W31: IH-10 Boerne Stage to Old Fredericksburg Sanitary Sewer

Job No.: 09-2502

ADDENDUM 2

October 4, 2016

SHEET NUMBER **C - 10**
 SHEET 63 OF 135

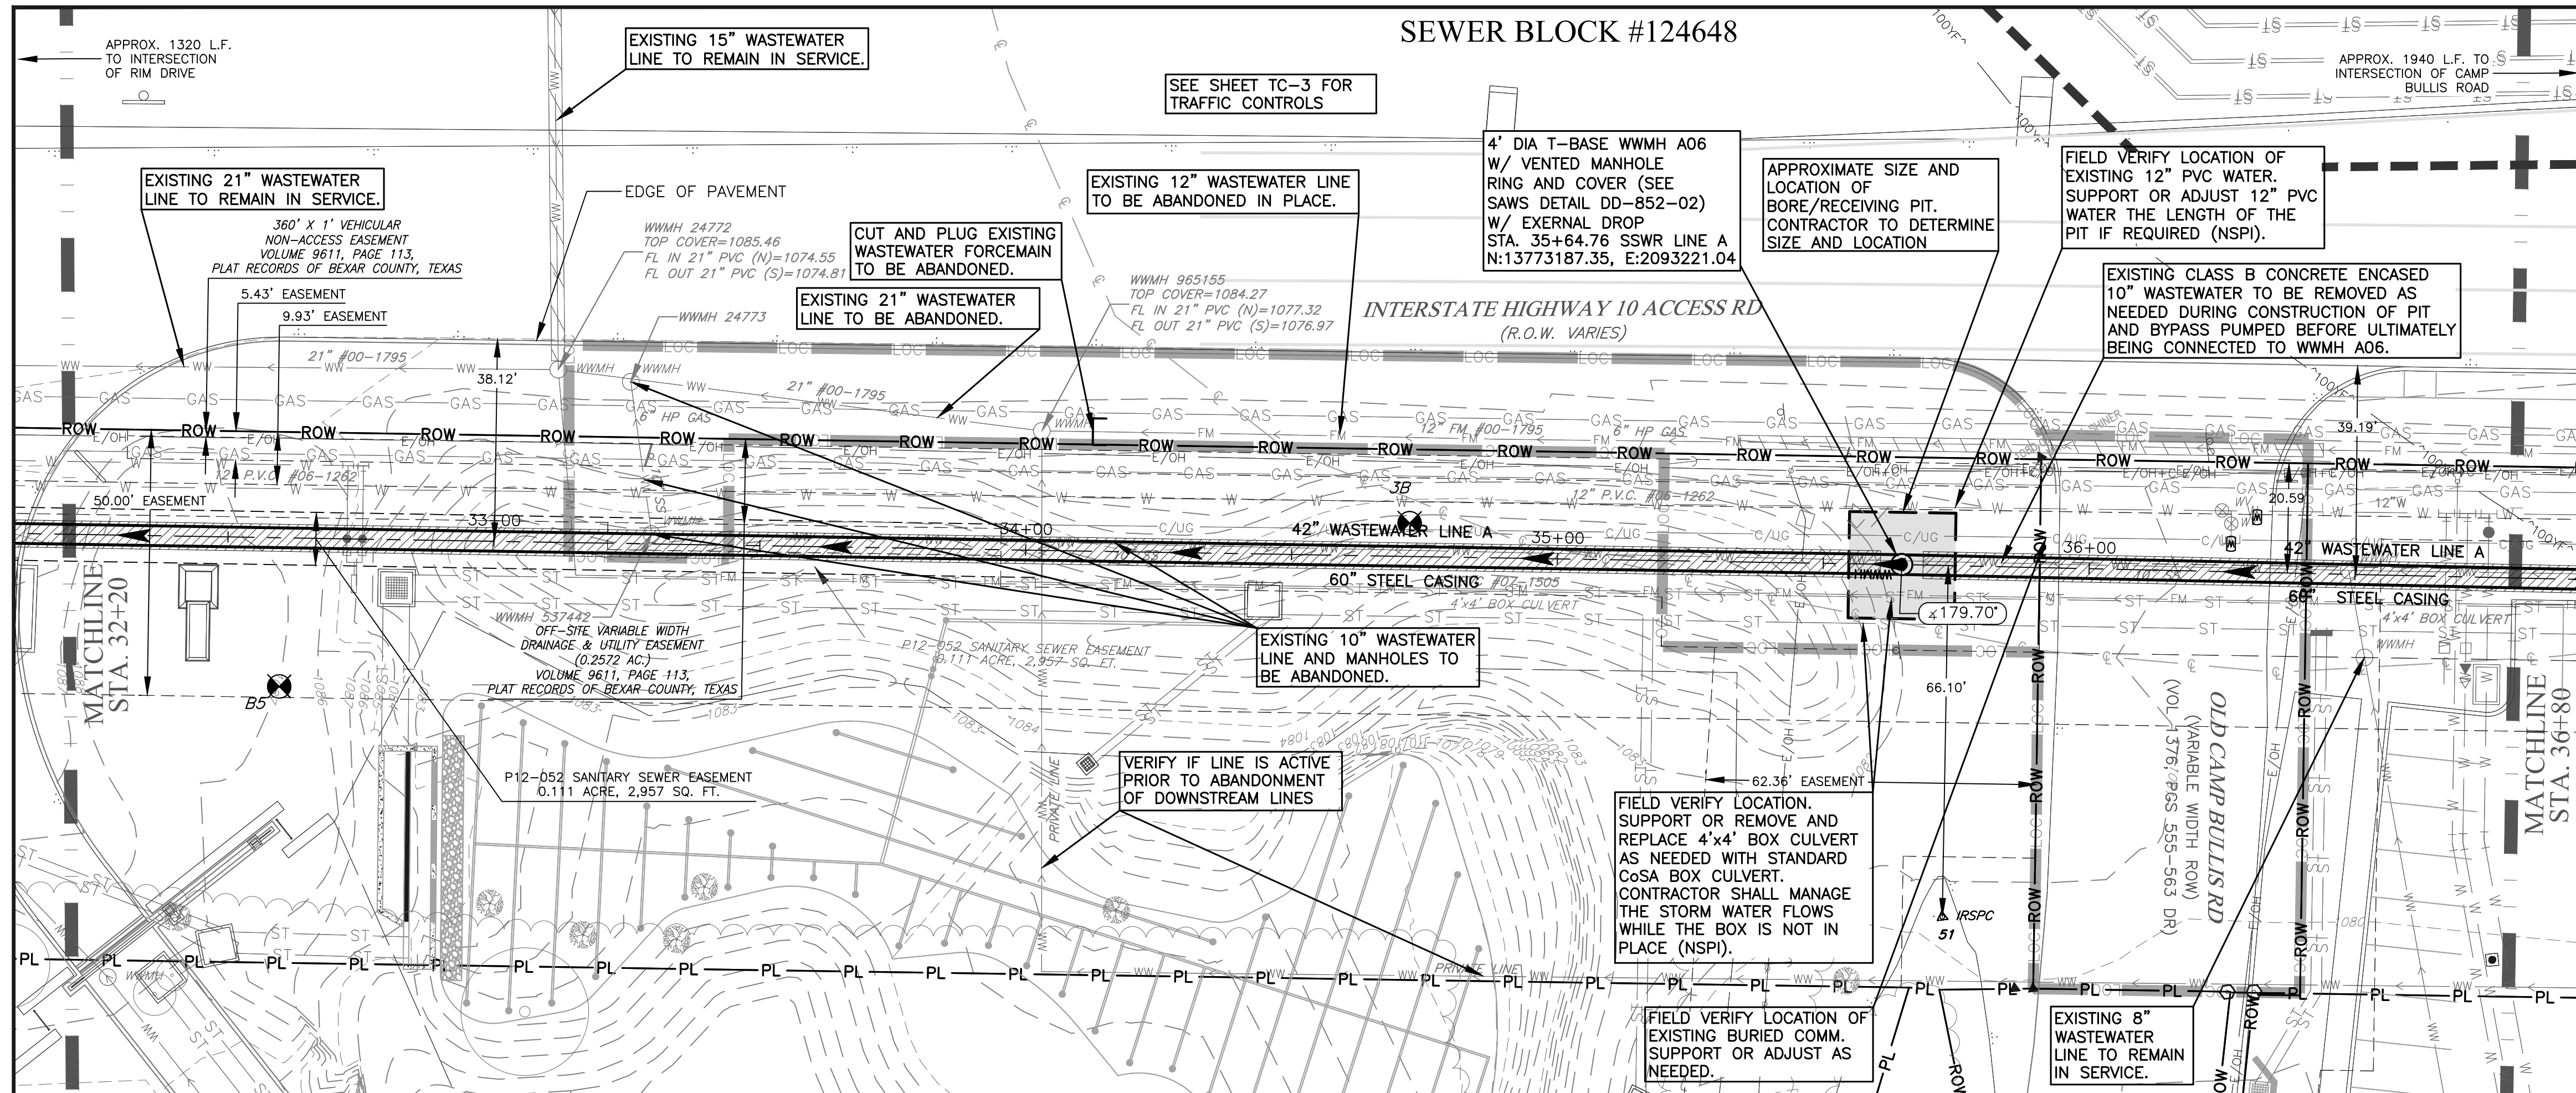
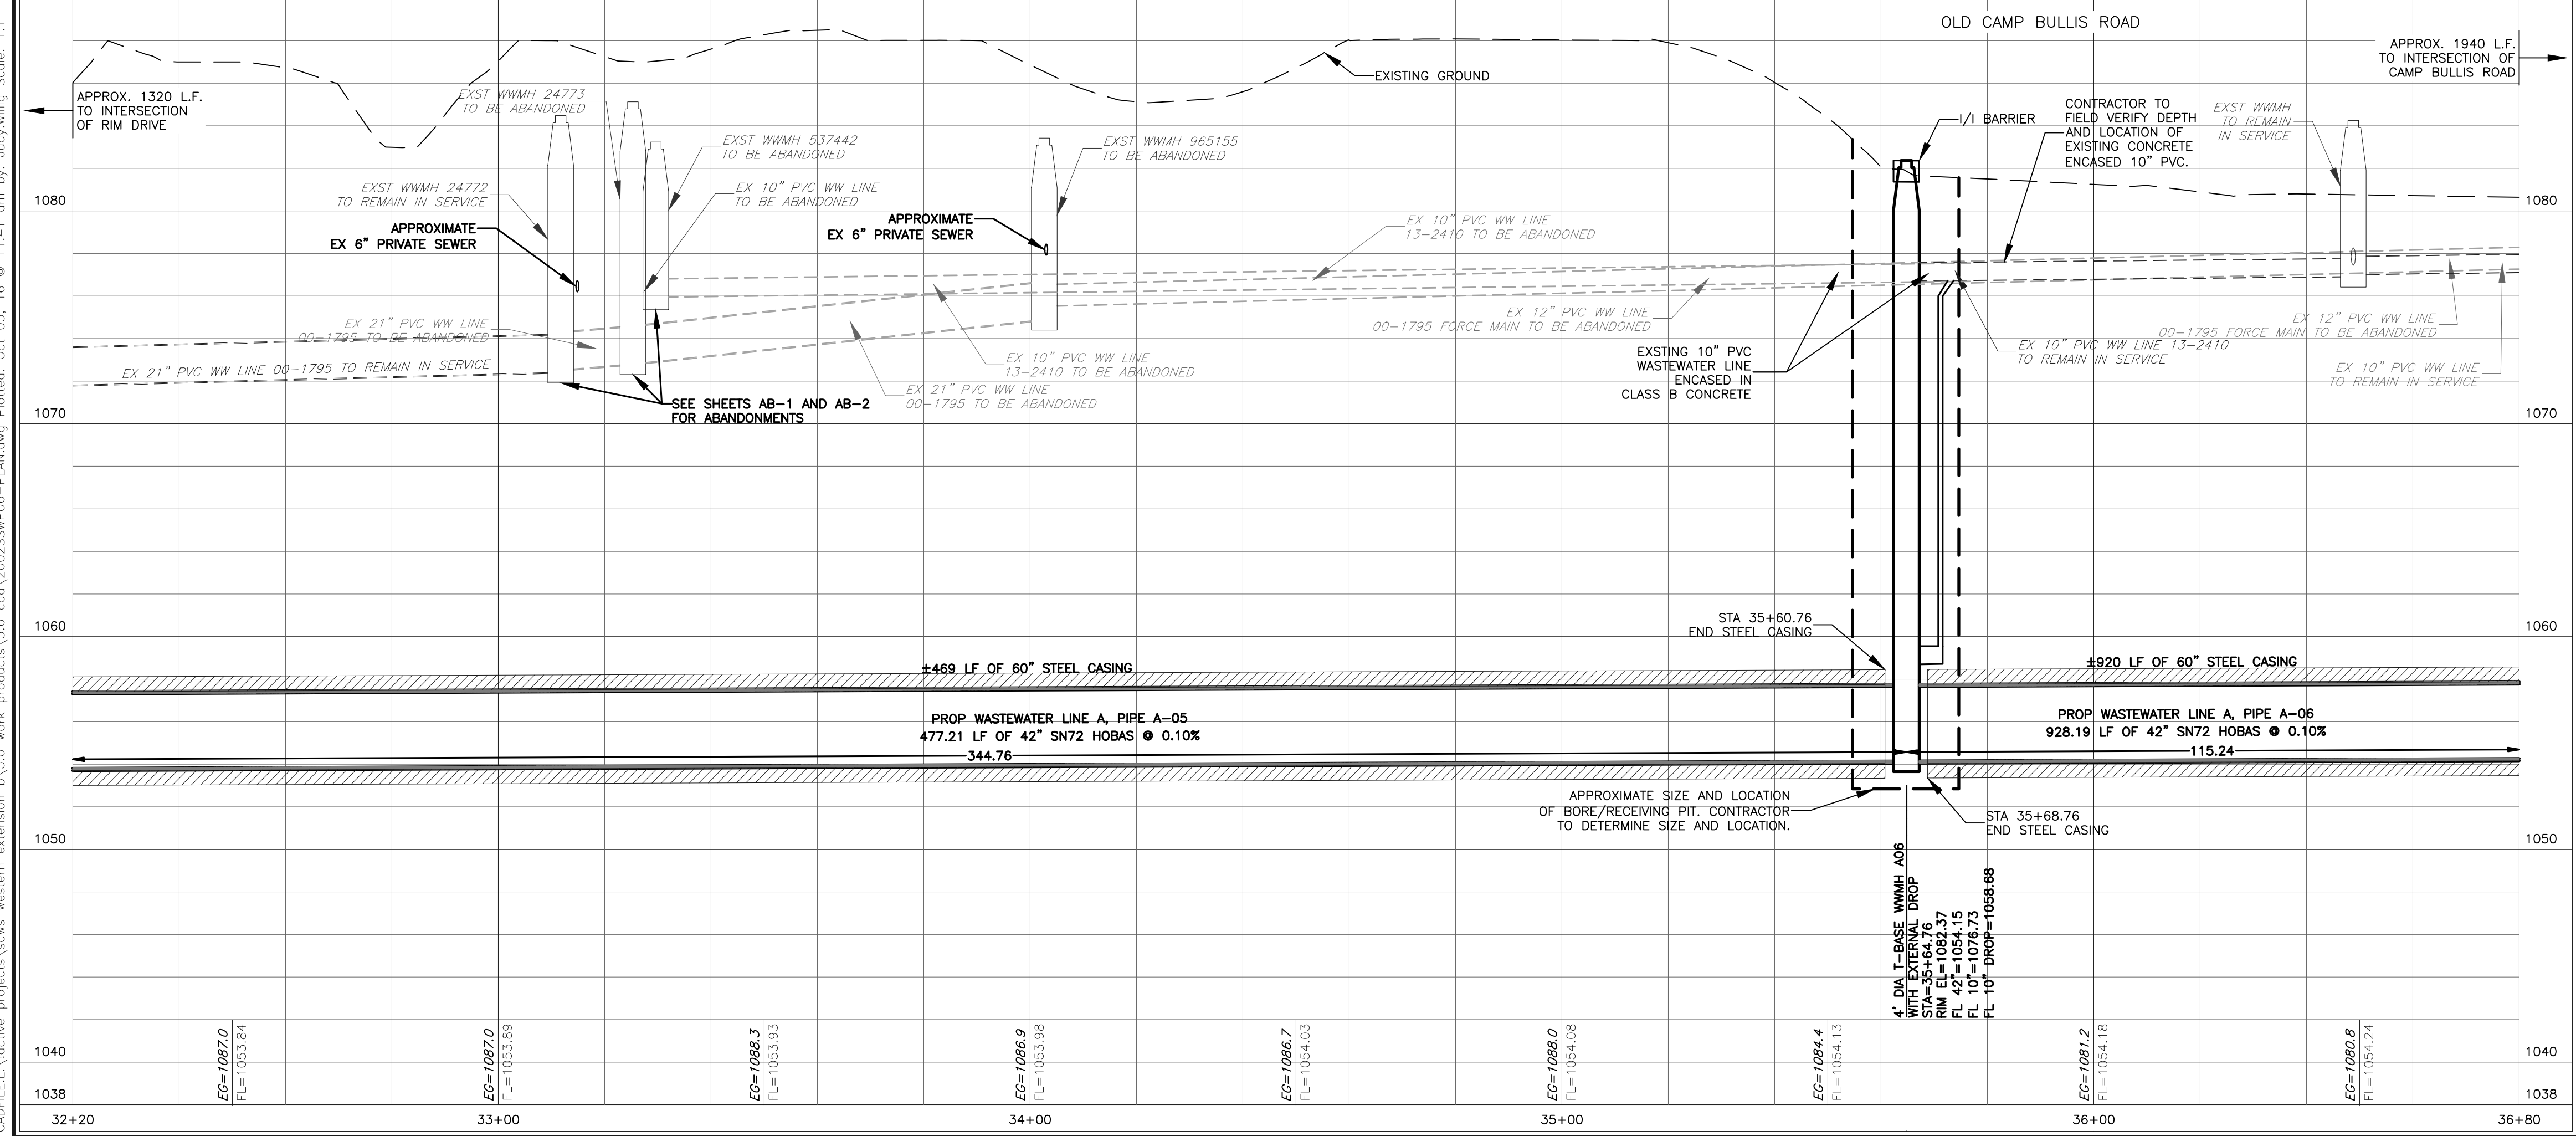
3. The following note was added to Sheets C-9, C-10, C-12, C-13, C-14, C-15, C-45, and C-46:

"The Contractor shall provide the property owner a written notice of initial entry 10 days prior to start construction within their property."

SPECIAL NOTE:
 1. THE CONTRACTOR SHALL PROVIDE THE PROPERTY OWNER A WRITTEN NOTICE OF INITIAL ENTRY 10 DAYS PRIOR TO START CONSTRUCTION WITHIN THEIR PROPERTY.
